AGREENACARBON PROJECT

Report ID	VCS.VAL.22.89 (Verification)
Project title	AgreenaCarbon Project
Project ID	4022
Verification period	15-September-2021 to 31-December-2023
Original date of issue	25/02/2025 is the date the audit was completed.
Most recent date of issue	10/09/2025 is the date on which the document was most recently submitted
Version	2.2
VCS Standard Version	4.7
Client	Agreena ApS
Prepared by	Earthood Services Limited
Approved by	Deepika Mahala
Work carried out by	Team Leader: Kaviraj Singh

Earthood Services Ltd. (Earthood) has carried out the verification assessment of the project activity “AgreenaCarbon Project” VCS 4022. The project activity falls under sectoral scope 14, Agriculture Forestry and Other Land Use (AFOLU) type and category Agriculture Land Management (ALM) and eligible ALM activity being Improved Cropland Management (ICM) as per the VCS Standard, v4.7. This is a large-scale project which involves implementation of improved agricultural land management activities that will lead to emission reductions and removals. The project is being implemented by Agreena ApS and supported by contractors and advisors. The latest version of approved VCS methodology V

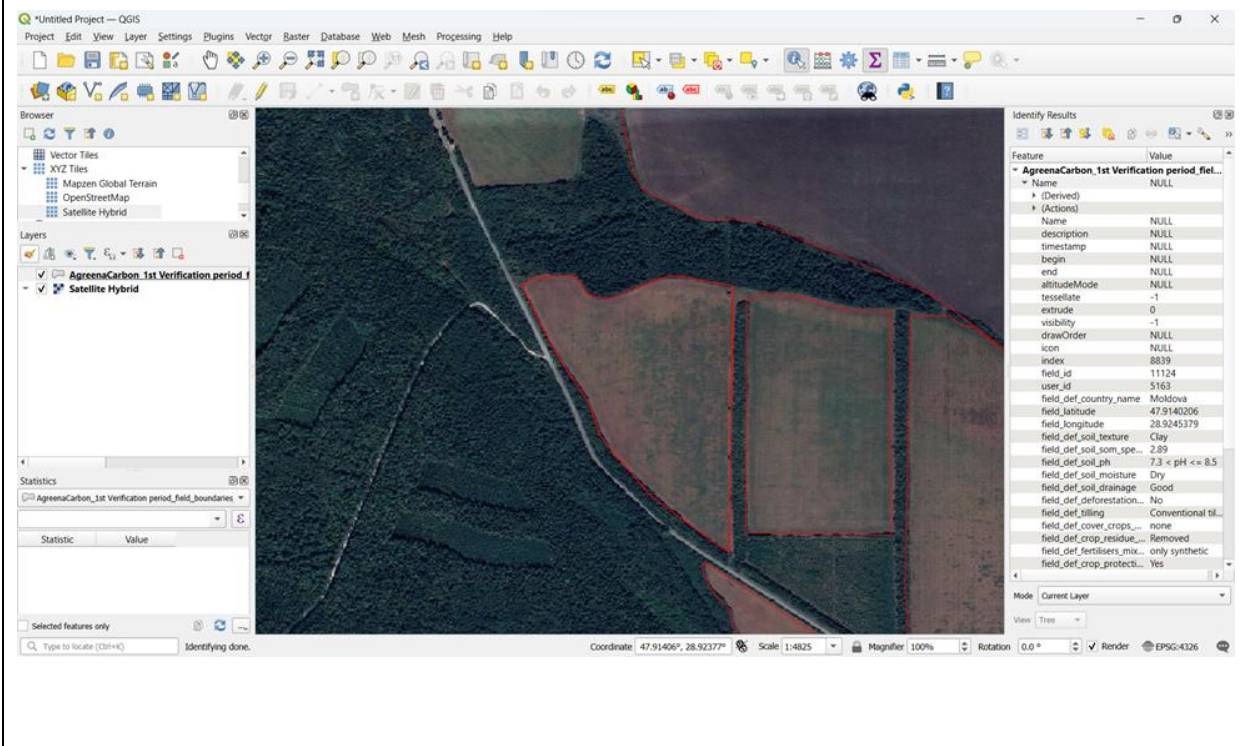
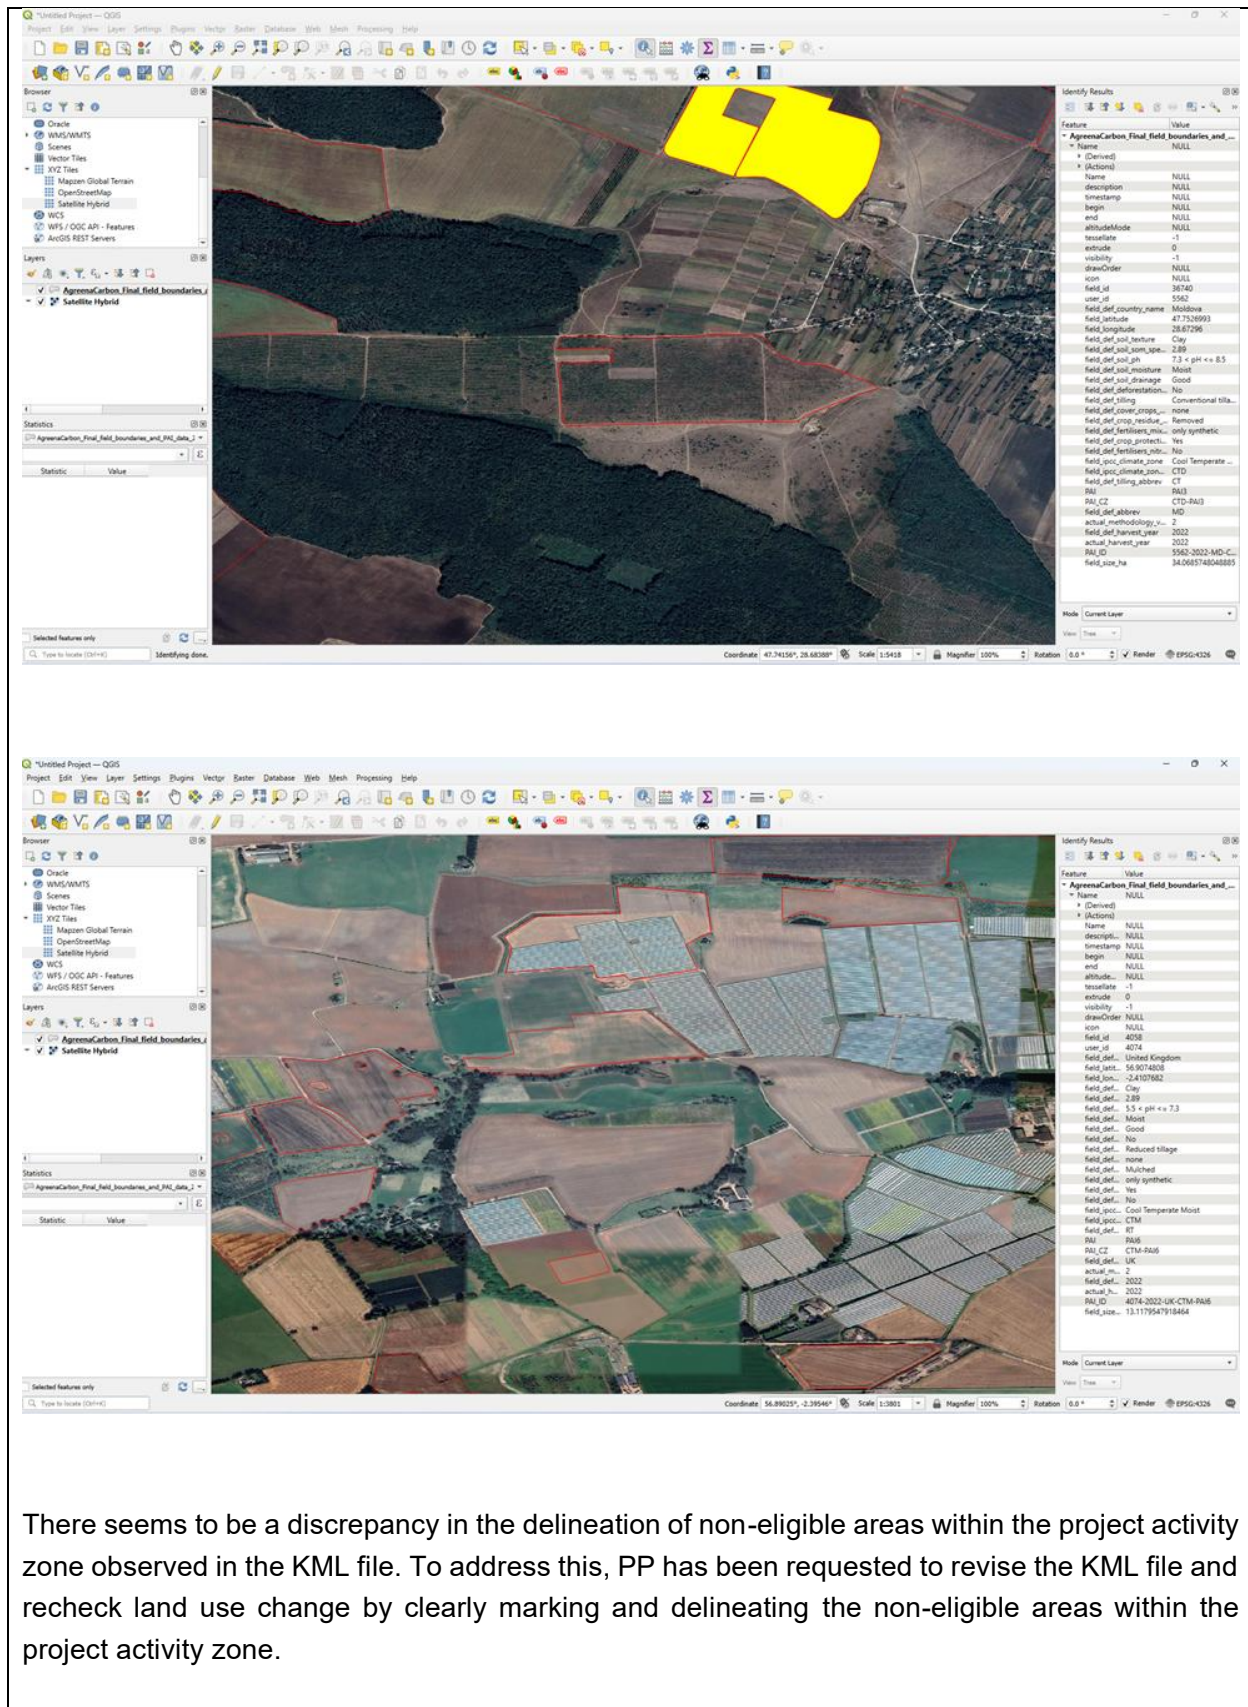
The MR document entitled “AgreenaCarbon_Monitoring_Report_1st_Verification_Period_V4_20231219_Clean.docx” provided by PP presents conflicting information regarding the total project area:

1. Section 4.3.2: States the total project area as 340,534.9 hectares for 12,560 fields.
2. Table 1-2 of MR (for 790 PAIs): Indicates the total project area as 505,327.26 hectares.
3. KML: Shows a different total area of 505,519.42 hectares for 18,017 fields.

The inconsistency between these figures prompts a request for PP to clarify and reconcile the discrepancy in the reported project area. Understanding and rectifying these inconsistencies are crucial for ensuring the accuracy and reliability of the project's data and documentation.

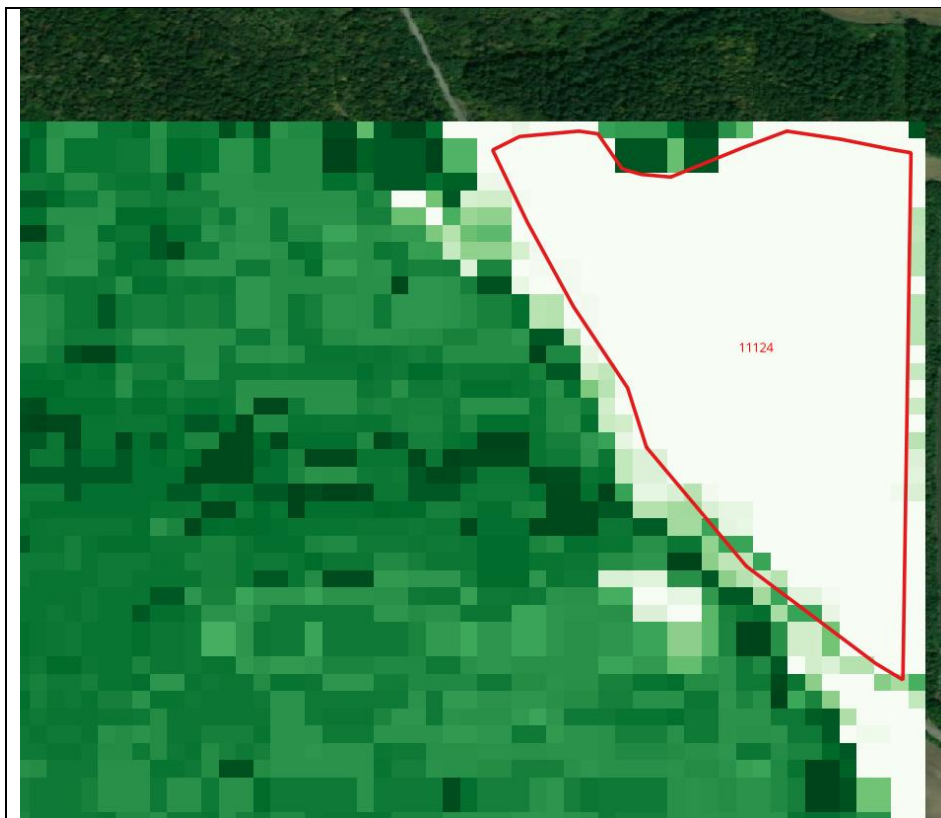
The deforestation process is better understood visually, therefore I have added the images below to further aid in visually understanding the result.

First image below shows the field 11124 outlined as a red polygon. The white pixels in the image means that no forest was recorded in 2000. The green pixelated boxes around it are understood to be forest, the colour darkness indicating percentage forest cover (0-100 %). *Note: that there is a satellite image placed behind the deforestation data, which is why you see a sharp boundary between pixelated modelled imagery and real satellite imagery.*

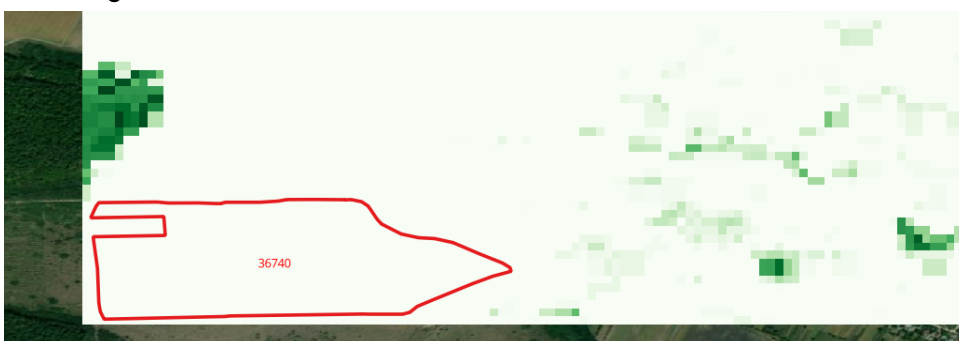
The image below shows the same for field 36740 with no deforestation detected:

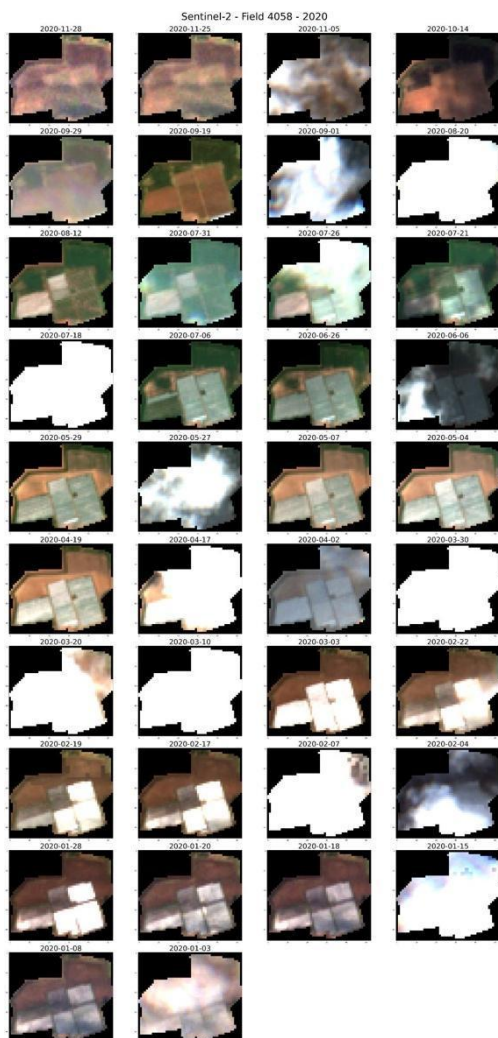
For the investigation into field 4058, imagery was assessed from the farmer's baseline period 2016 and up until the end of 2023. The farmer entered the programme in 2021 and no polytunnels were detected in the year that the farmer became an Agreea farmer. The following imagery is imagery from 2020 shows that there were no poly tunnels in 2020 and information about the baseline is as follows.

Farmer tillage baseline in ERRs: Reduced Tillage

Farmer remote sensing detected baseline: No tillage

Agreea decision from QA 2022: Yellow flag from remote sensing resulted in an assessment of the field and while farmer was regularly doing no-tillage while having polytunnels, Agreea

took the conservative decision for his baseline to be reduced tillage in order to account for the existence of the tunnels.

Figure 1 Overview properties United Kingdom based on SoilGrids as compared to aggregated CVD for clay (left) and SOC (right). Provided by Agreena to IME 04-09-2023.

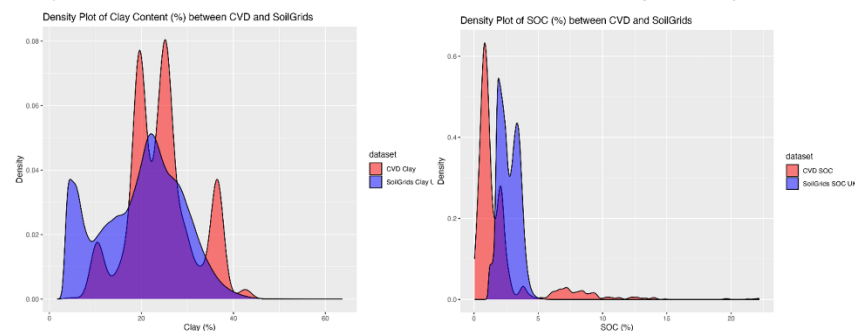
CL ID	09	Section no.	Date : 20/08/2024
Description of CL			
Document name: Supplement to model validation and calibration report, v4.0 dated 16/08/2023 (page 10)			
Recommendation 14: The Project can leverage open data sources such as SoilGrids to get an estimate. If the range overlaps the models are appropriate. If they do not overlap, we recommend extending the dataset for calibration and validation. We recommend the Project provide details

IMEs confirm that this recommendation was closed during the last (third) IME review. The Agreena team has put in an effort to extend the CVD so that they cover the range found in the project, as exemplified in The Third IME review Figure 1 (see below).

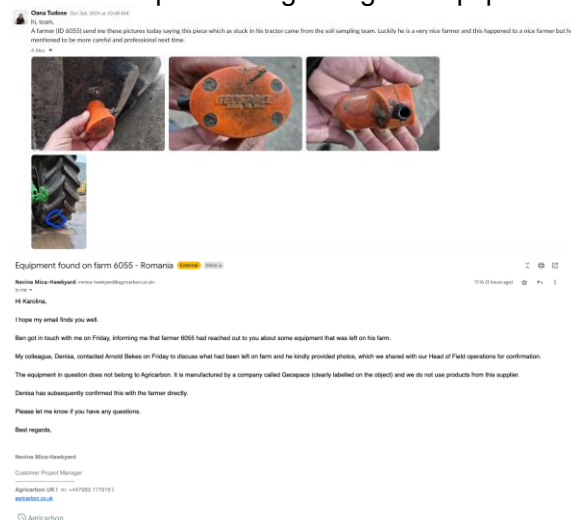
Project participant response	Date : DD/MM/YYYY
The AgreeenaCarbon grievance procedure ensures that farmers can file formal complaints if need be and they would be assessed on whether an escalation is needed. Still, due to the nature of the Project and the close communication between the CS team and farmers at Agreeena, farmers typically write to Agreeena via WhatsApp or phone call, as they have close relationships with their representatives. These complaints are then delegated to the right person or team to resolve the matter amicably and in a culturally appropriate manner. This is outlined in Section 2.2.6 of the PD. - For User 5116, there has been no grievance record submitted and email communication or phone communication have not identified grievances or complaints towards the Project itself. The only evidence of a complaint was when the User could not change his password on the platform which was registered on WhatsApp. This was resolved over the phone. The following picture is the message sent regarding the password reset issue as proof of tracking and recording of the complaint.  - For User 6055, the only evidence of a grievance was a minor complaint submitted to the Customer Success team on October 24, 2024 in reference to potential soil sampling equipment left, not by Agreeena, but by the soil sampling team. The complaint was logged and investigated and it was found that the soil sampling equipment is not from the company with which Agreeena partners for soil sampling and this was communicated

with the farmer as follow-up. The attached screenshot depicts this. The benefit contract has also been shared with the VVB. The following pictures show the message sent regarding the equipment as proof of tracking and recording of the complaint as well as the follow-up email regarding the equipment.

1.The Grievance Redressal Procedure has been described in Section 2.1.4 of the MR. The process described in the PD and MR are as per the Sections 3.18 and 3.19 of the standard v4.7. Further, there was a minor complaint made by the farmer (USER ID 5116) through a Whatsapp message. This was resolved over WhatsApp by Agreena team. There was no formal complaint raised by the farmer. The information has been reviewed and found to be correct. The benefit Therefore, this finding is closed.
